# Access Compliance Report

## Public Rights-of-Way

Intersection ID: 19542	Main Street: PROVIDENCE_RD	Cross Street: STRAWBERRY_HILL_DR	Location:	N
ADA ID: 3E0A79D35C06	Ramp Type: PerpDiag	Initial Pass/Fail: Fail	Overall Compliance: No	Severity Score: 22.5

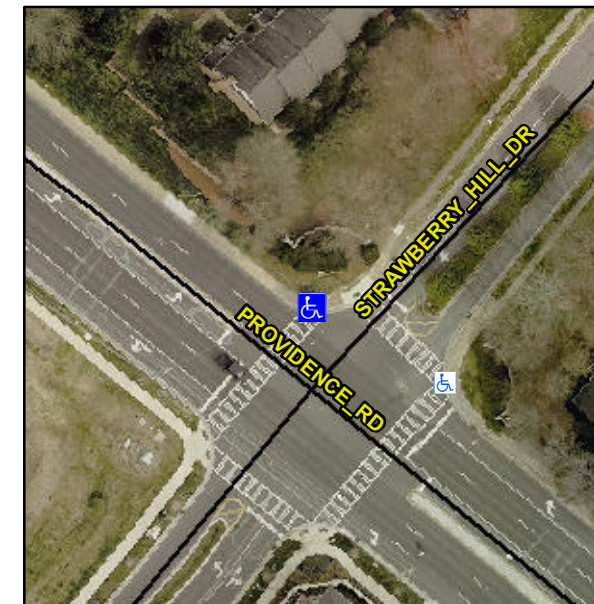
**Not Found, R304.5.1, R304.2.2, R304.5.3**

Compliance	Description	Data	Compliance	Description	Data
N/A	Ramp Length (in)	71.0	No	Ramp Slope (%)	9.0
No	Ramp Width (in)	41.0	No	Ramp XSlope (%)	4.6
N/A	Flare Type LT	N/A	N/A	Flare Type RT	N/A
N/A	Flare Slope LT (%)	N/A	N/A	Flare Slope RT (%)	N/A
N/A	Flare Traversable LT?	N/A	N/A	Flare Traversable RT?	N/A
N/A	Landing Length (in)	N/A	N/A	DWS Provided?	N/A
N/A	Landing Width (in)	N/A	N/A	DWS Contrast?	N/A
N/A	Landing Slope (%)	N/A	N/A	DWS Length (in)	N/A
N/A	Landing X Slope (%)	N/A	N/A	DWS Full Width?	N/A
N/A	Landing Curb? (Y/N)	N/A	N/A	DWS Offset (in)	N/A
N/A	Shared Landing?	N/A			
N/A	Gutter Ponding?	N/A	N/A	Gutter Slope (%)	N/A
N/A	Gutter Lip Ht (in)	N/A	N/A	Gutter X Slope (%)	N/A
N/A	Painted X Walk1?	No	N/A	Painted X Walk2?	No
	X Walk 1 Direction	To SW		X Walk 2 Direction	To SE
N/A	X Walk 1 Width (in)	N/A	N/A	X Walk 2 Width (in)	N/A
	X Walk 1 Slope (%)	0.9		X Walk 2 Slope (%)	5.2
	X Walk 1 X Slope (%)	3.7		X Walk 2 X Slope (%)	1.4

**Remove & Replace Curb Ramp With Two New Directional Ramps or Equivalent.**
